Access Compliance Report Public Rights-of-Way (Curb Ramps)

Intersection ID: N/A Main Street: BALLANTYNE_COUNTRY_CLUB_DR Cross Street: COYLE_CR Location: SE

ADA ID: A7C299B0E9AB Ramp Type: Perp Initial Pass/Fail: Fail Overall Compliance: No Severity Score: 13.75

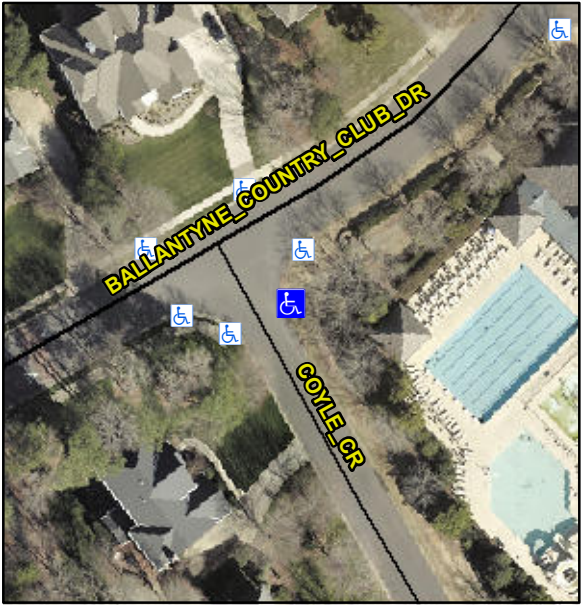
PROW/ADA:
Not Found, R304.2.2, R304.5.3

Compliance	Description	Data	Compliance	Description	Data
N/A	Ramp Length (in)	64.0	No	Ramp Slope (%)	8.8
Yes	Ramp Width (in)	48.0	No	Ramp XSlope (%)	2.7
N/A	Flare Type LT	N/A	N/A	Flare Type RT	N/A
N/A	Flare Slope LT (%)	N/A	N/A	Flare Slope RT (%)	N/A
N/A	Flare Traversable LT?	N/A	N/A	Flare Traversable RT?	N/A
N/A	Landing Length (in)	N/A	N/A	DWS Provided?	N/A
N/A	Landing Width (in)	N/A	N/A	DWS Contrast?	N/A
N/A	Landing Slope (%)	N/A	N/A	DWS Length (in)	N/A
N/A	Landing X Slope (%)	N/A	N/A	DWS Full Width?	N/A
N/A	Landing Curb? (Y/N)	N/A	N/A	DWS Offset (in)	N/A
N/A	Shared Landing?	N/A			
N/A	Gutter Ponding?	N/A	N/A	Gutter Slope (%)	N/A
N/A	Gutter Lip Ht (in)	N/A	N/A	Gutter X Slope (%)	N/A
N/A	Painted X Walk1?	No	N/A	Painted X Walk2?	N/A
	X Walk 1 Direction	To SW		X Walk 2 Direction	N/A
N/A	X Walk 1 Width (in)	N/A	N/A	X Walk 2 Width (in)	N/A
	X Walk 1 Slope (%)	0.9		X Walk 2 Slope (%)	N/A
	X Walk 1 X Slope (%)	1.8		X Walk 2 X Slope (%)	N/A

Possible Solutions:
Remove & Replace Entire Ramp.
